Product Change Notification / MAAN-24WWNV902

CCB 6777.001 Initial Notice: Qualification of ANAP as an additional assembly site for selected ATSAM4S16B, ATSAM4S8B, ATSAM4SA16B, ATSAM4S2B, ATSAM4N16B, ATSAM4SD16B, ATSAM4N8B, ATSAM4SD32B and ATSAM4S4B device families available in 64L LQFP (10x10x1.4mm) package.

CCB 6777.001
Pre and Post Change Summary
PCN #: MAAN-24WWNV902

ASSH

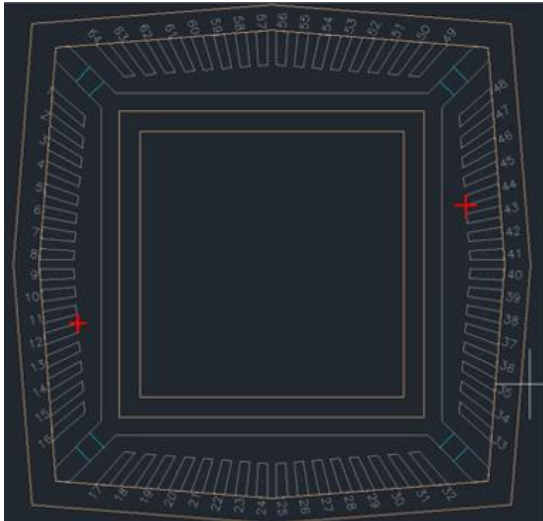
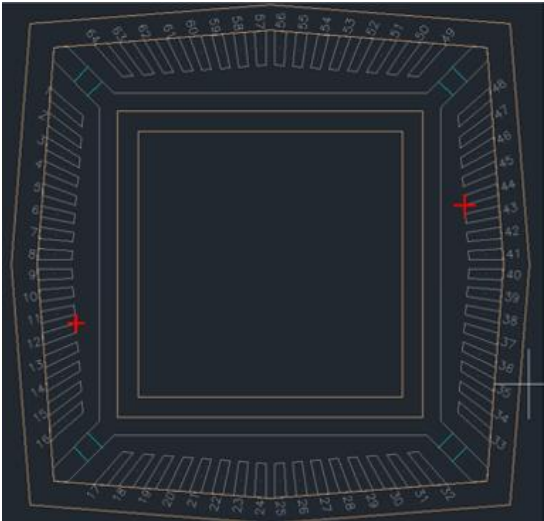
Paddle Size	260X260
Lead-Frame material	C7025

Paddle Size	200X200
Lead-Frame material	C7025

ANAP

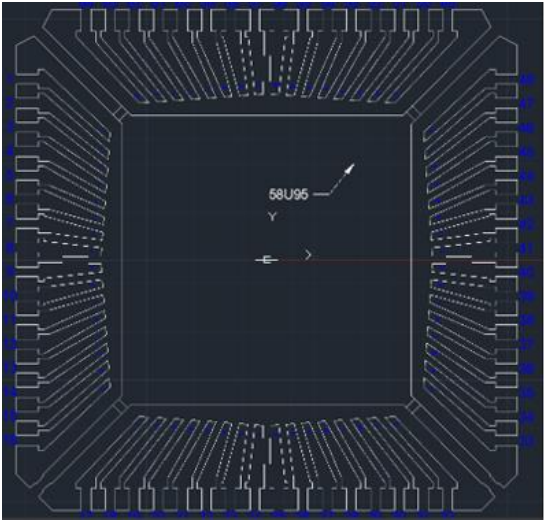
Paddle Size	236X236
Lead-Frame material	C194ESH
